January 18, 1974

Subject: Dresden Station Unit 3 - Proposed Change to Facility Operating License DPR-25, AEC Dkt 50-249

Pursuant to Section 50.59 of 10 CFR 50 and Paragraph 3.B of the facility operating license DPR-25, Commonwealth Edison Company submits a proposed change to Appendix A of DPR-25. The purpose of this change is to modify the limiting conditions of operation related to densification. These modifications are based on the results of reanalyses using the model discussed in General Electric Topical Report NEDO-20181. The proposed change is indicated on the attached revised pages 81B, 81C, 85A and 85B.

FIGURE 3.5.1 - MAXIMUM ALLOWABLE PLANAR LHGR

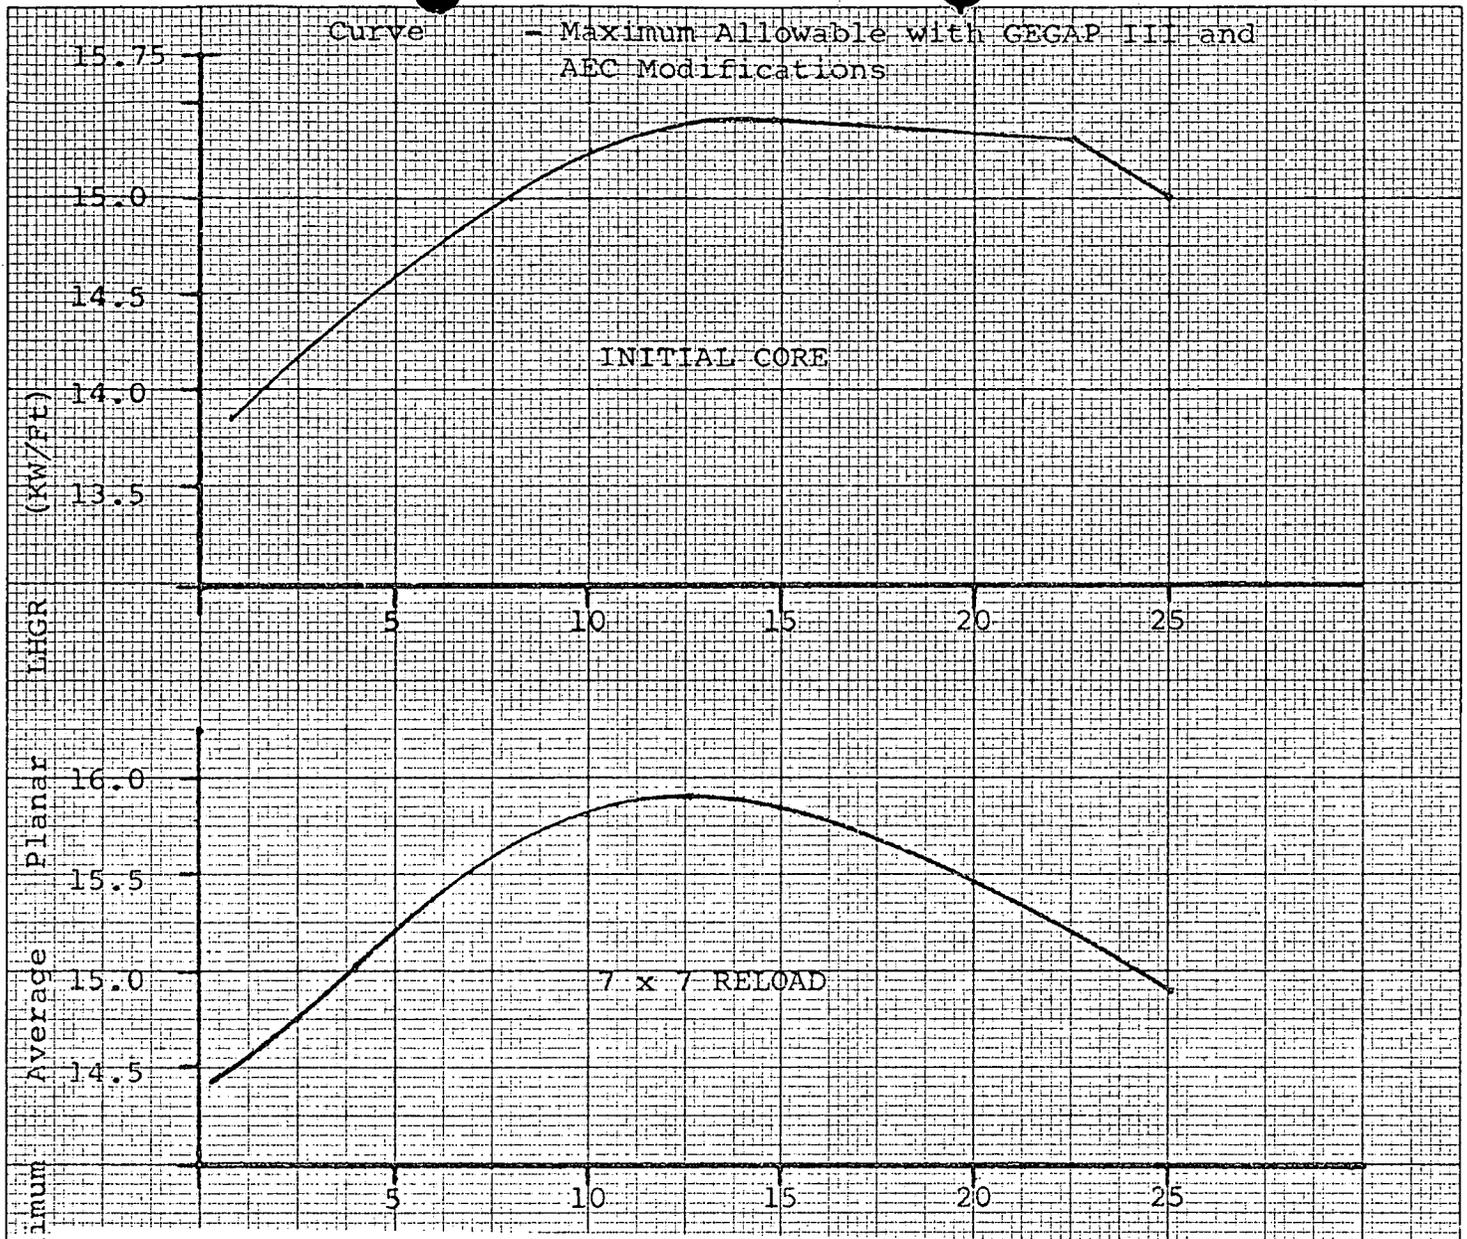
This proposed change includes revised maximum average planar linear heat generation rate (MAPLHGR) limits for the two (2) types of 7 x 7 lattice fuel which are currently in use in the reactor. The MAPLHGR limits for 8 x 8 lattice fuel were proposed as part of Supplement C to the Second Reload License Submittal, submitted December 6, 1973. A proposed Technical Specification revising the 8 x 8 lattice fuel MAPLHGR limits consistent with the gap conductance model described in General Electric Company Report NEDO-20181 (GEGAP-III) is being submitted separately as Supplement H to the Dresden Unit 3 Second Reload License Submittal.

During steady state power operation, the average linear heat generation rate (LHGR) of all the rods in any fuel assembly, as a function of average planar exposure, at any axial location, shall not exceed the maximum average planar LHGR shown in Figure 3.5.1.

The maximum average planar LHGR's shown in Figure 3.5.1 are based on calculations employing the models described in the General Electric Report NEDM-10735 as modified by General Electric Report NEDO-20181.
